PLANNING BOARD MEETING AGENDA

Re: Wickes Arborists – 11 McNamara Road
Response to Site Plan and Special Permit Review comments

The following are in response to comments prepared by Brooker Engineering, PLLC dated May 23, 2023.

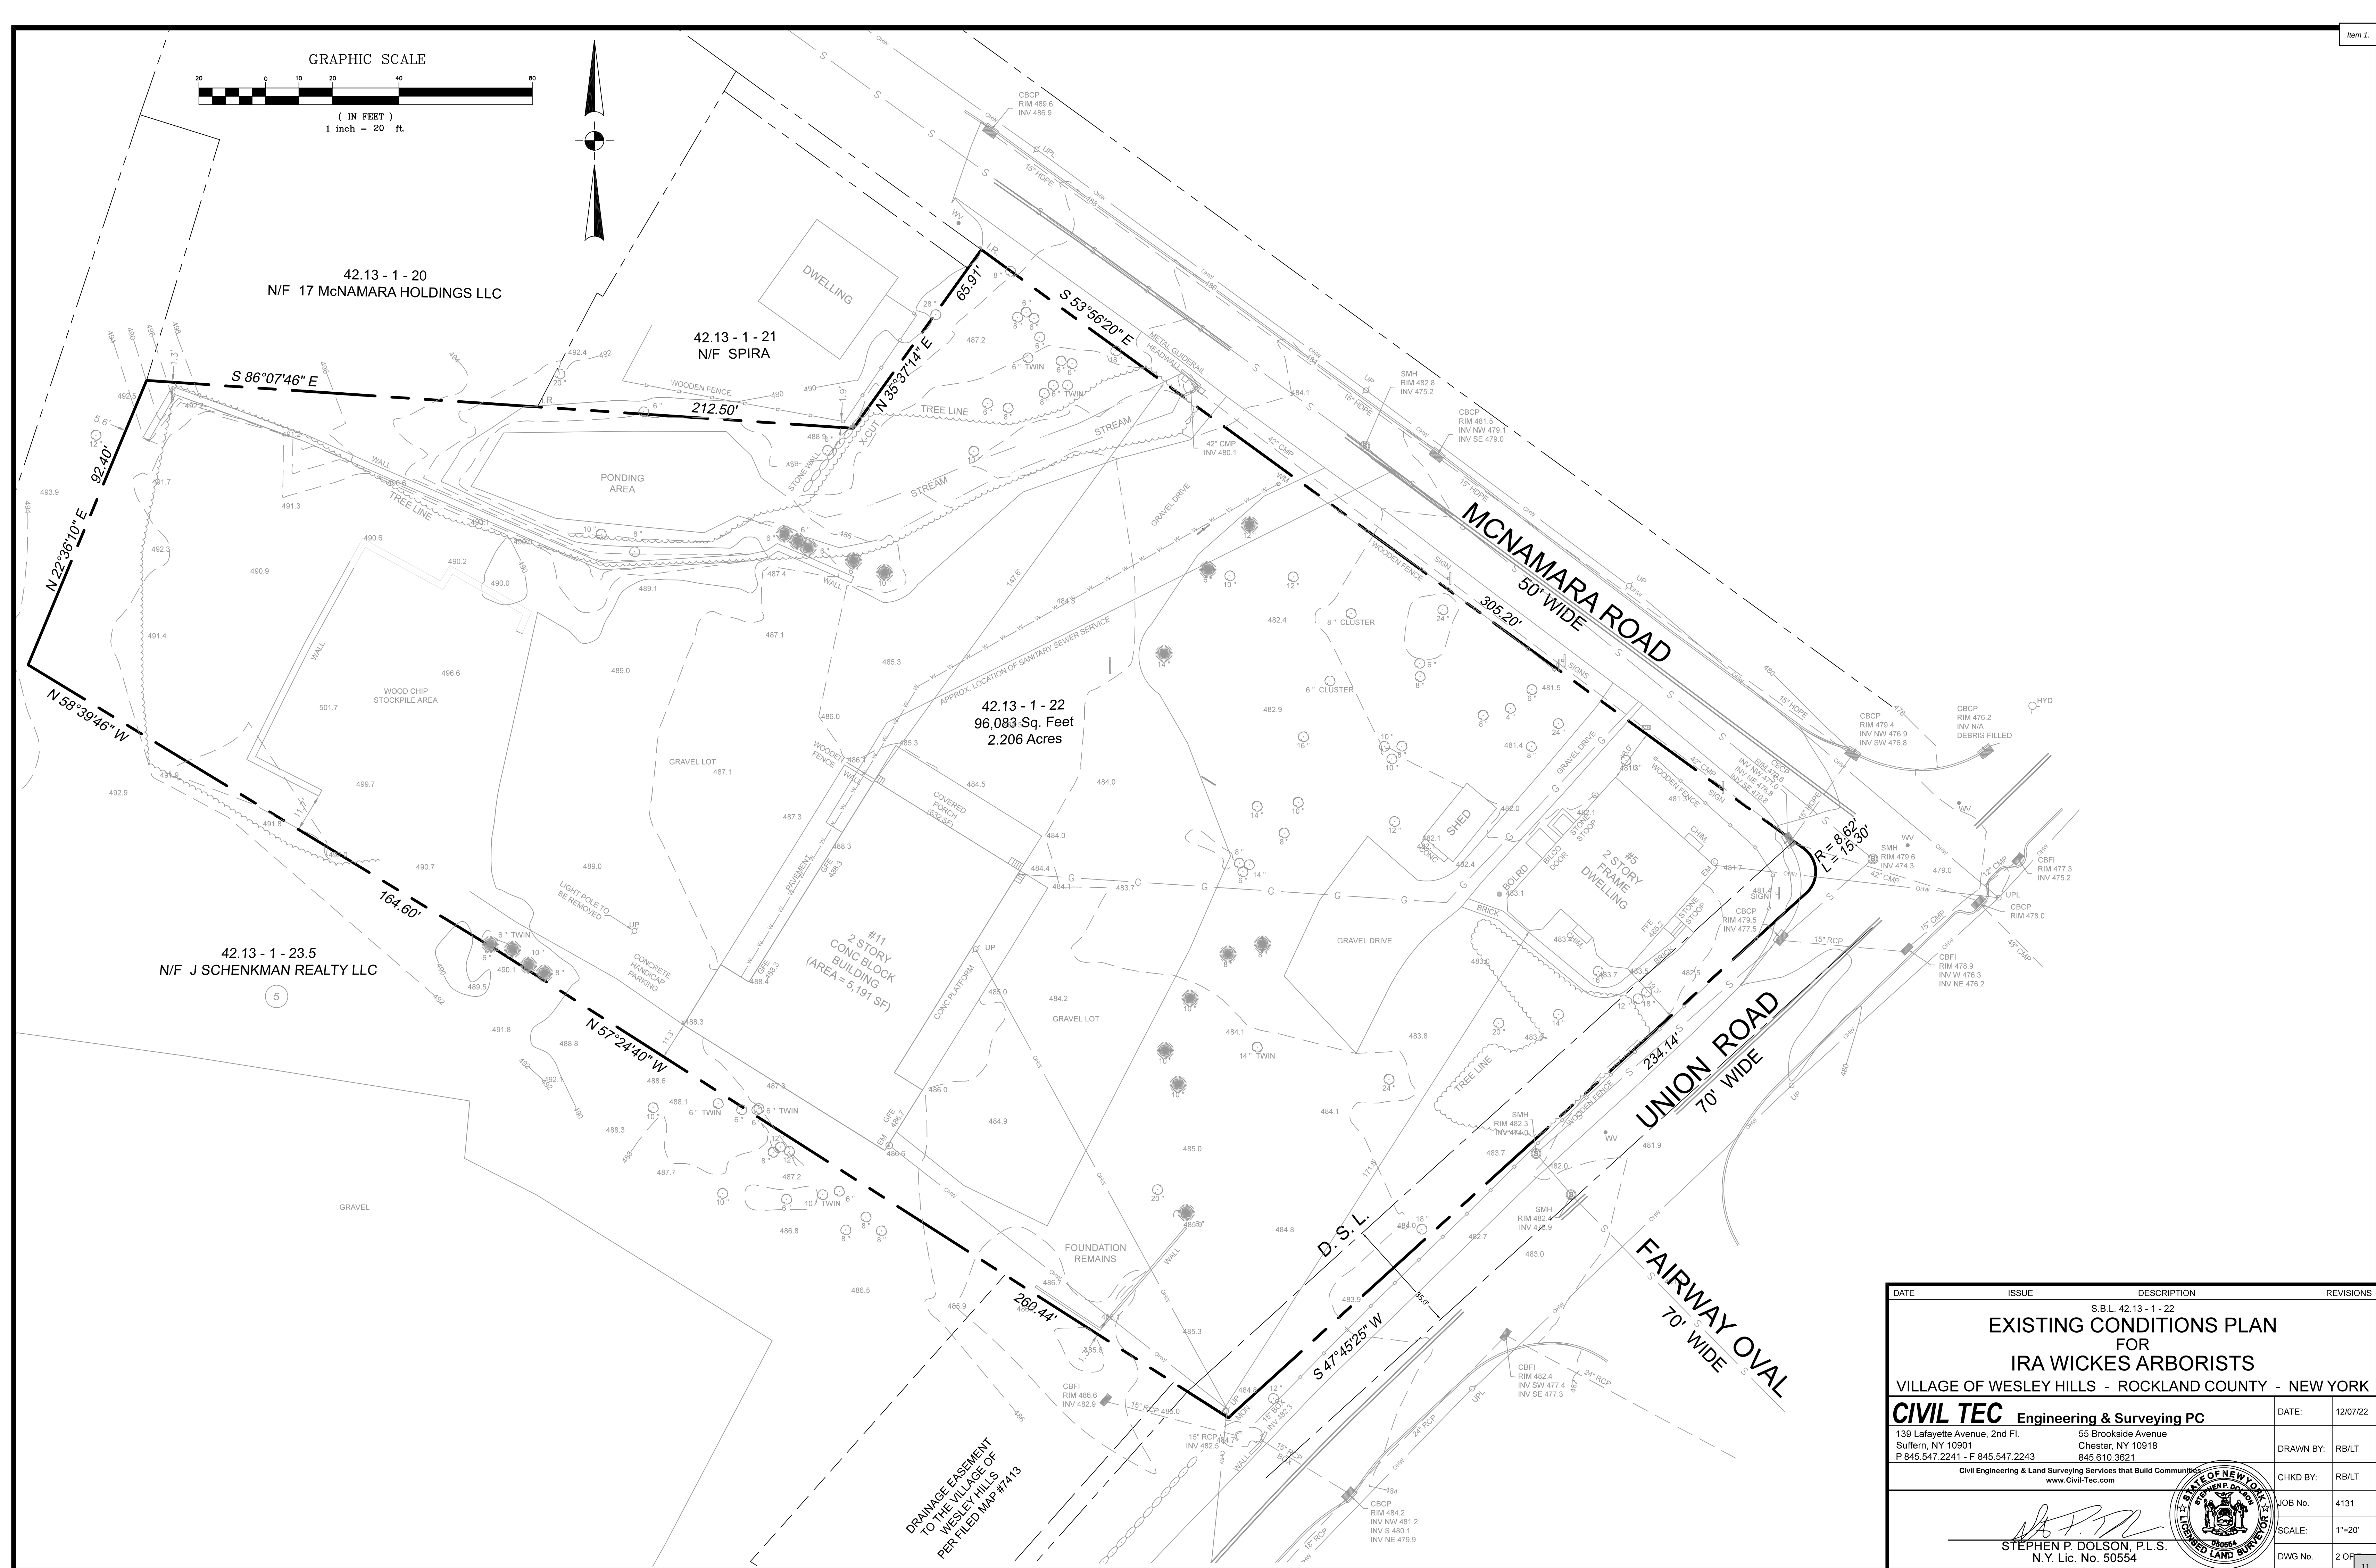
- 9. Various site plan elements appear to be absent from the previously approved site plan, including but not limited to:**

A thorough review shall be performed to confirm all previously approved site plan elements have been incorporated to the new plans.

2. Regarding comment 2 of our previous memorandum dated May 22, 2023, **we have no problem with the gated emergency access drive connecting the east parking area to Union Road.** We believe this would satisfy the condition of the Court decision without any undue adverse impact to Union Road. The grasscrete installation will provide a lawn appearance and will not add impervious surfaces to the site. **A comment letter was received from the Fire Inspector dated July 10, 2023, and the latest design on sheet 1 of the site plan set indicates it will be 26 feet in width as requested.**

Response: A thorough review of the approved site plan was performed, and revisions were made to the plans.

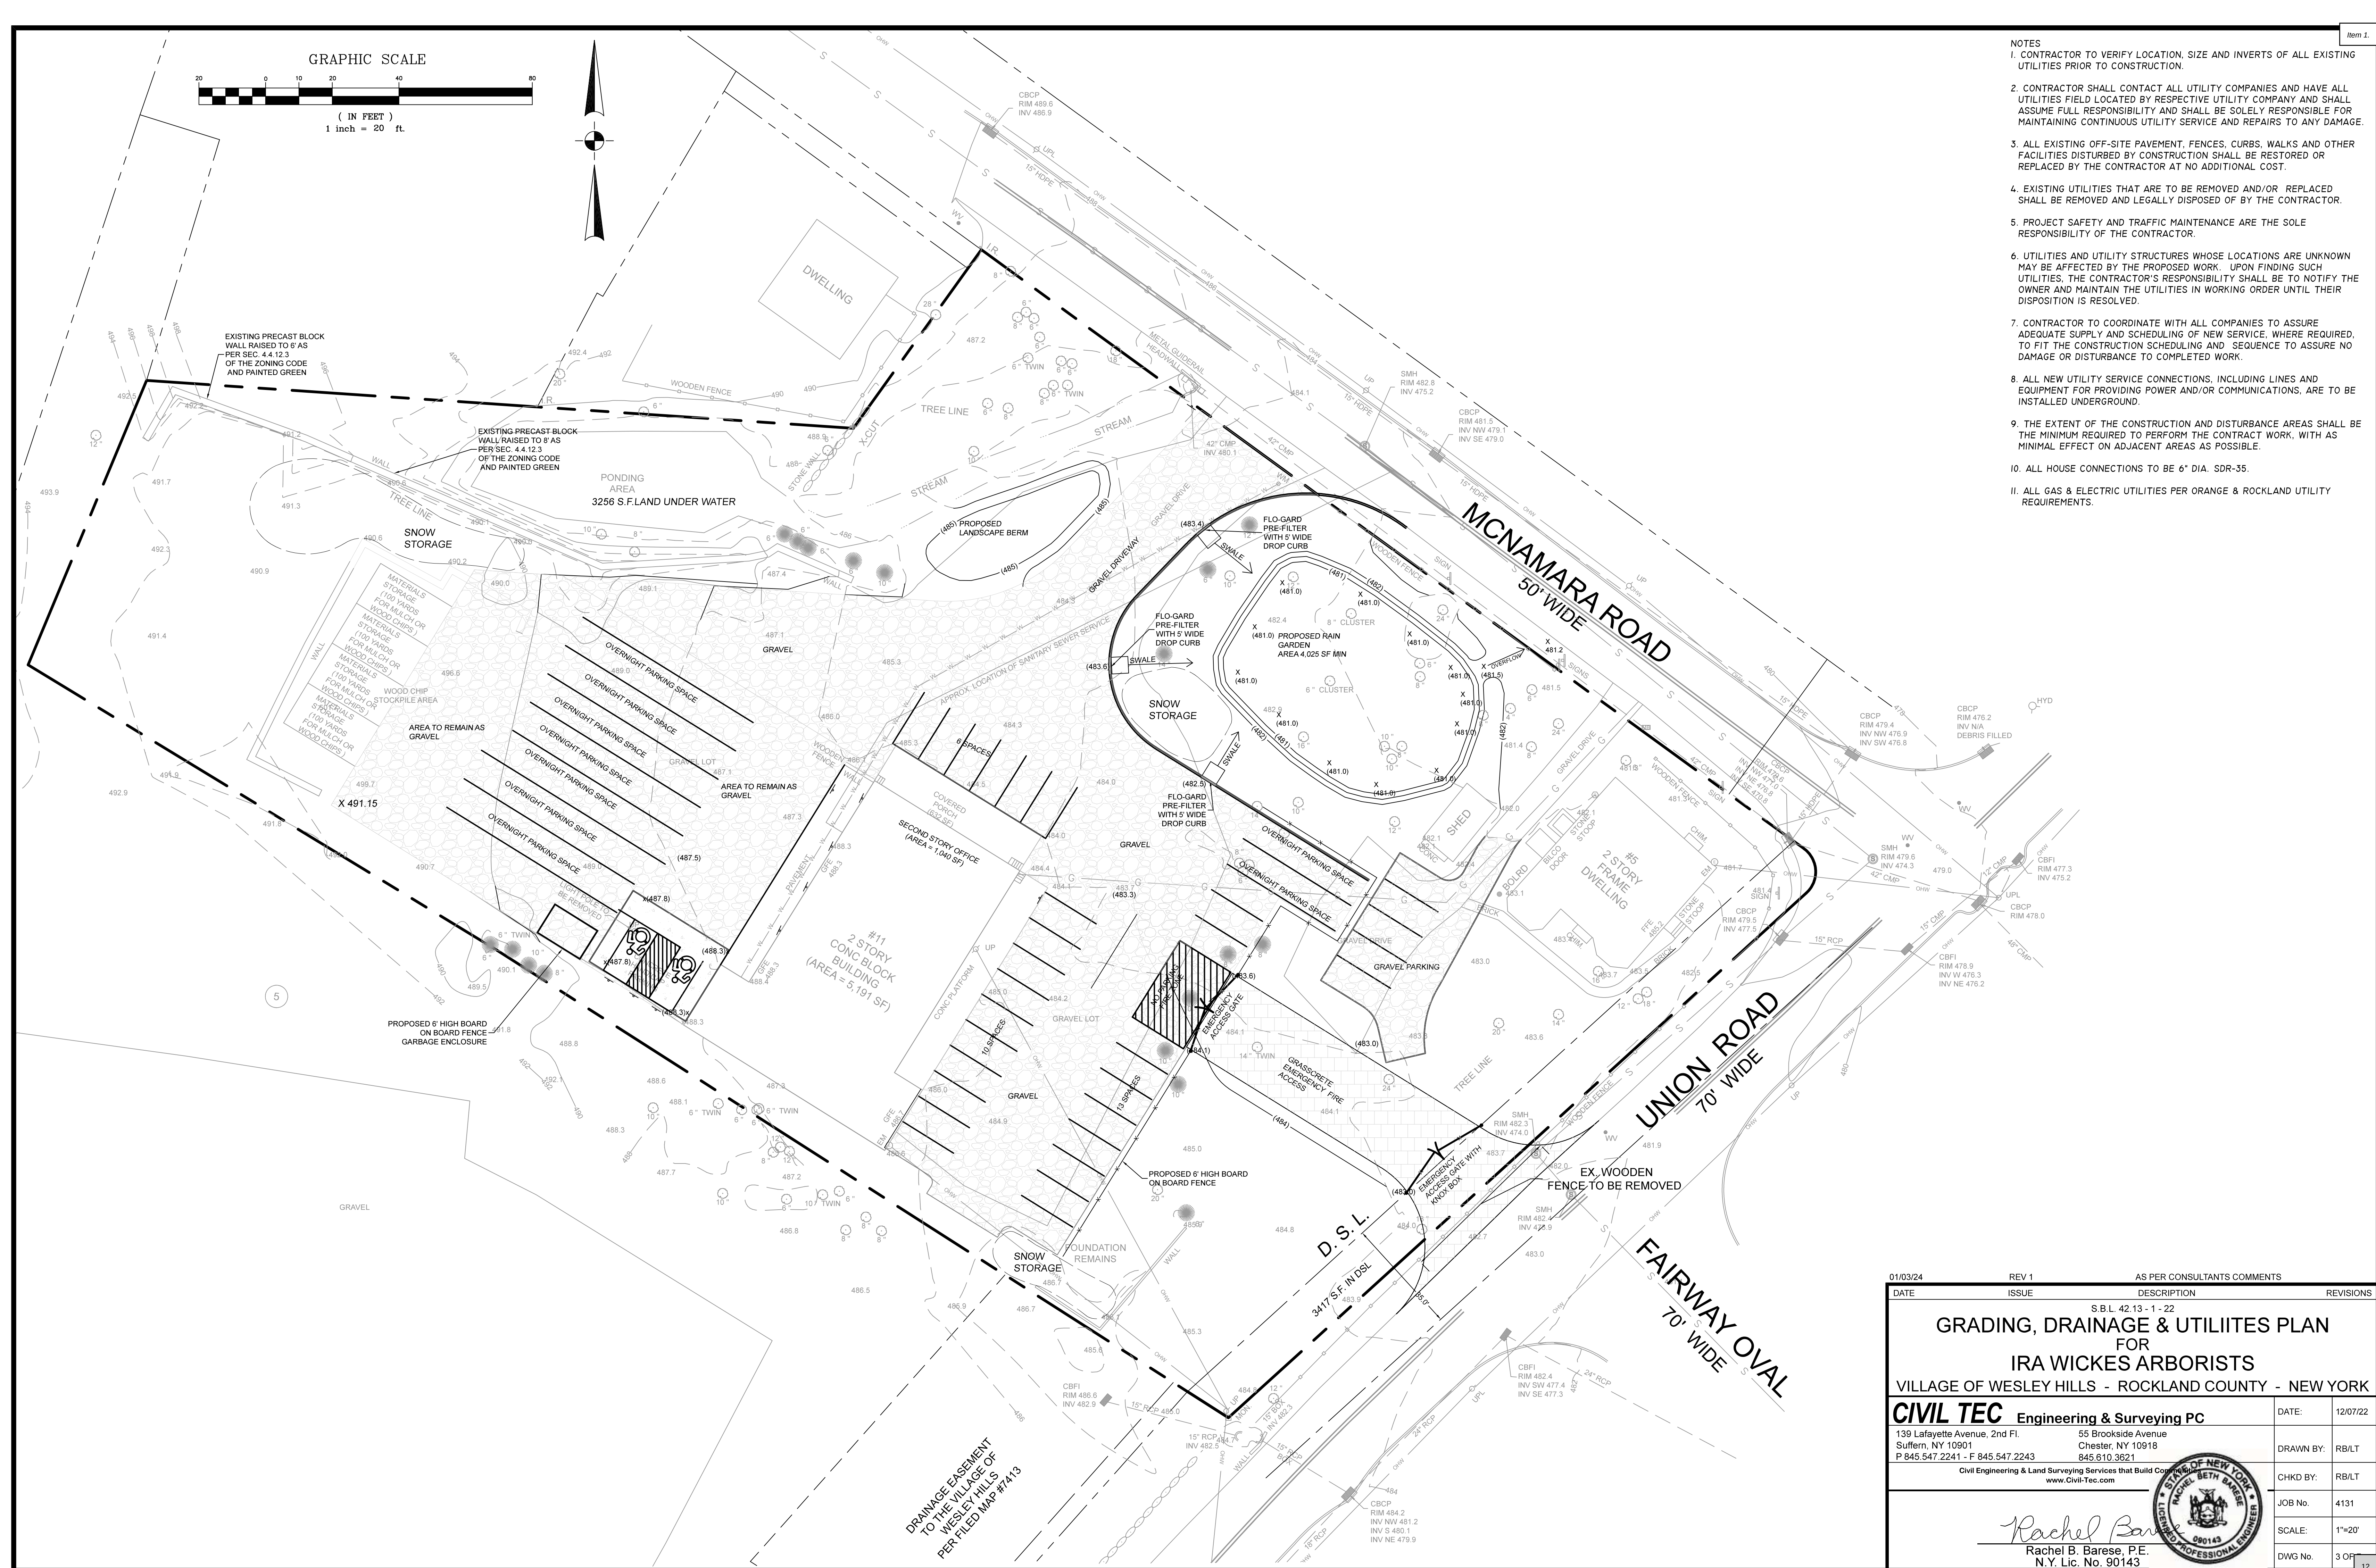
- 10. Grading detail is limited. Additional spot grades shall be provided to demonstrate:**

- 11. Additional drop curbs appear necessary to accommodate proposed configuration of catch basins/flo-gard prefilters. Outlet of catch basin to be clarified. Detail suggests a piped overflow is needed. Grading/inverts to be confirmed.**

- 13. The discharge point for the underdrain system and domed overflow riser are absent from the plan. Overflow invert, underdrain invert, and discharge location & invert shall be provided.**

Response: Additional spot grades have been provided to clarify the proposed grading in the named areas.

Response: An additional Drop curbs and an additional flo-gard pre-filter have been proposed. The overflow has been designed to flow overland in a grass swale to McNamara Road drainage system. An underdrain is not required in the rain garden if the soil infiltration rate is not sufficient. If soil testing determines an underrating is required, we will design it before construction.

Response: Overflow has been designed to flow overland in a grass swale to McNamara Road drainage system.

GRASSCRETE PERVIOUS PAVEMENT DETAIL

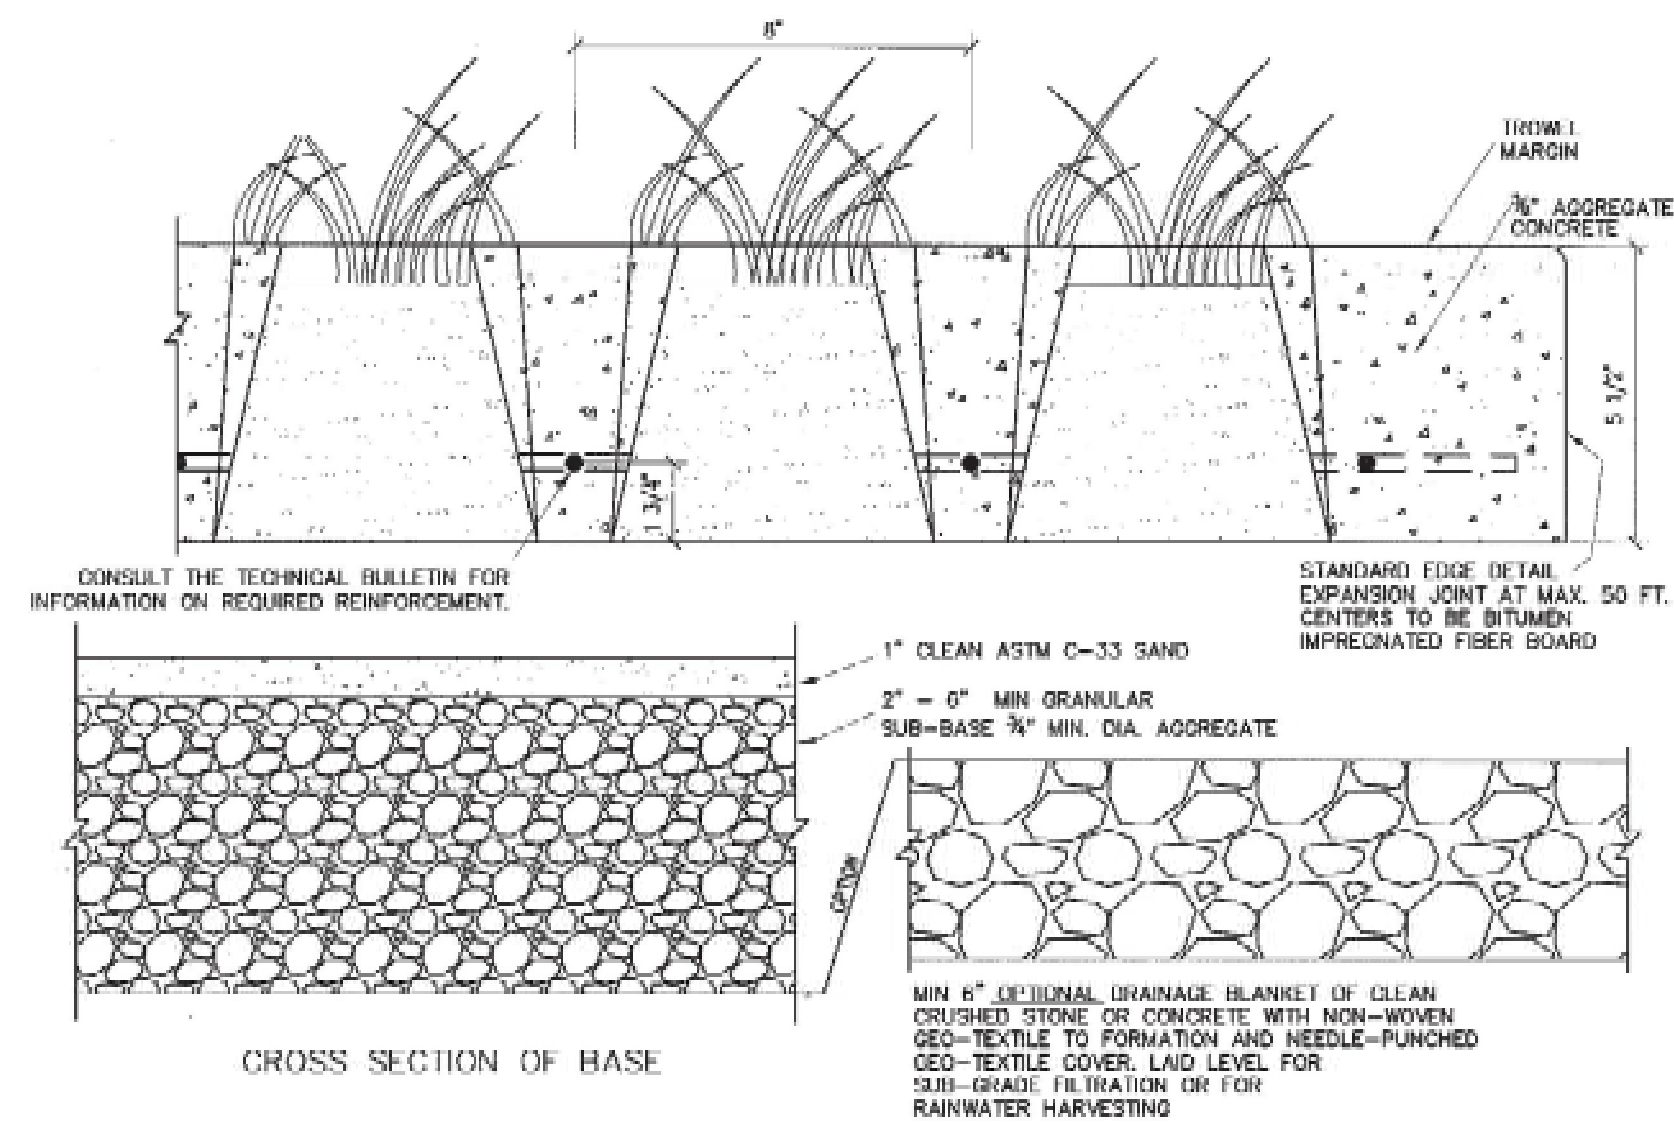
- 16. Grass-crete detail/cross section to be provided.**

Response: Additional Details have been provided.

CONCRETE CURB DETAIL

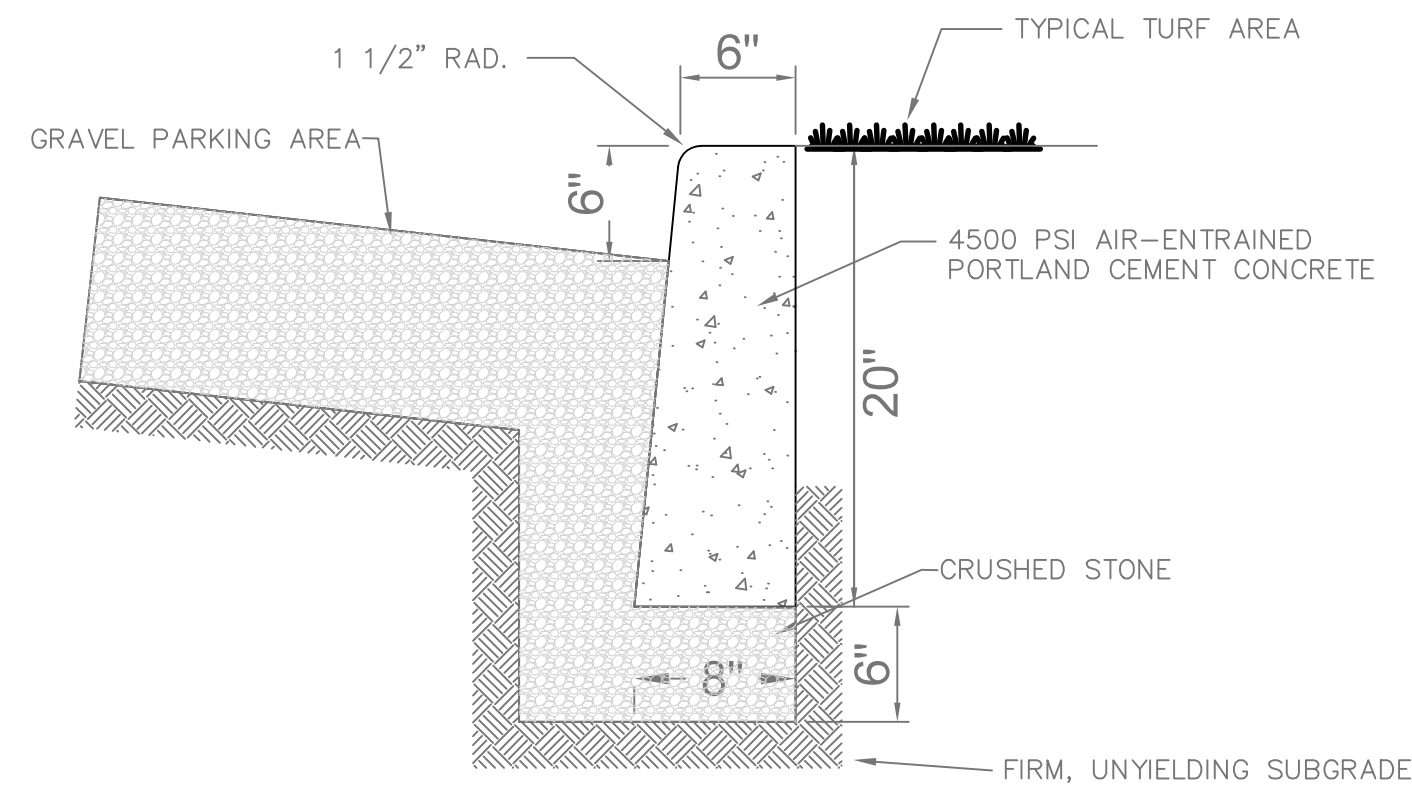
- 6. Proposed concrete curb limits to be confirmed. Previous plan set included only a limited area of concrete curb along the border of the rain garden to convey and pretreat stormwater runoff.**

Response: The Concrete curb is to be installed along the border of the rain garden to channel the flow into the rain garden through the pretreatment structures. The remaining concrete curbing has been removed.
